Neighborhood Notification for 14341 Browns Lane Between April 16th 2024 – March 6th 2025

14341 Browns Lane - Meeting to Discuss

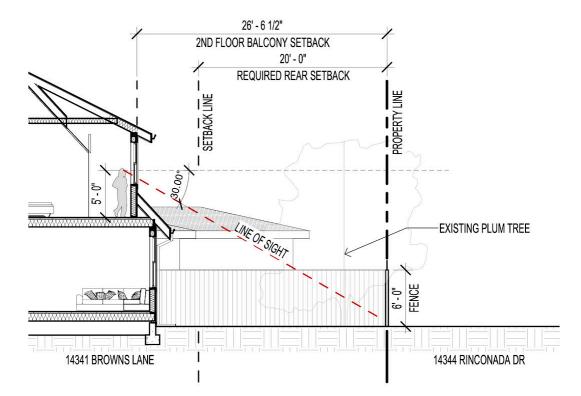
The below diagram doesn't do an adequate job of illustrating just how much someone standing on the second floor can see, so I'm attaching two photos. I placed a stake in the ground in our yard 20' from the fence line - the distance I estimate a 5' (below average height) person would be able to see the ground at given a 6' fence. I added a line parallel to the fence in red to highlight where the stake meets the ground. One photo faces 14341 Browns Ln, the other faces my house. For the latter, I held my camera above my head with my back against the fence - I'm 6' tall - and took a photo with the stake aligned to the bottom of the frame. This provides a very rough approximation of what someone could theoretically see.

A vast majority of our gardens, pool, patio, and grassy areas are exposed. The existing tree is insufficient, especially since it provides no privacy benefit for half of the year (when it has no foliage, as is the case now).

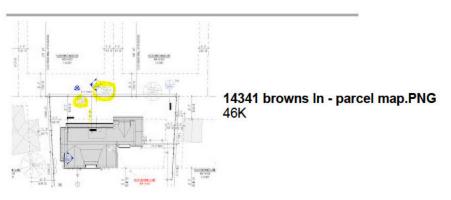
Can you give us a view on a parcel map, so we can see the location of the various aspects of the house in relation to our lot? In addition, we did not realize that there was a balcony in the rear of the house. How does this maintain our privacy when someone can just come out on the balcony and watch everything going on in our garden, pool and home areas?

Please see attached for the screenshot of the parcel map. The balcony lands in the line of sight between the 2 existing trees and we have inset the balcony 30+ feet away from the property line. All of the windows along the rear side will be opaque/frosted and we have reduced the overall size of the house. We have prioritized your privacy while balancing the needs of our client to our best ability.
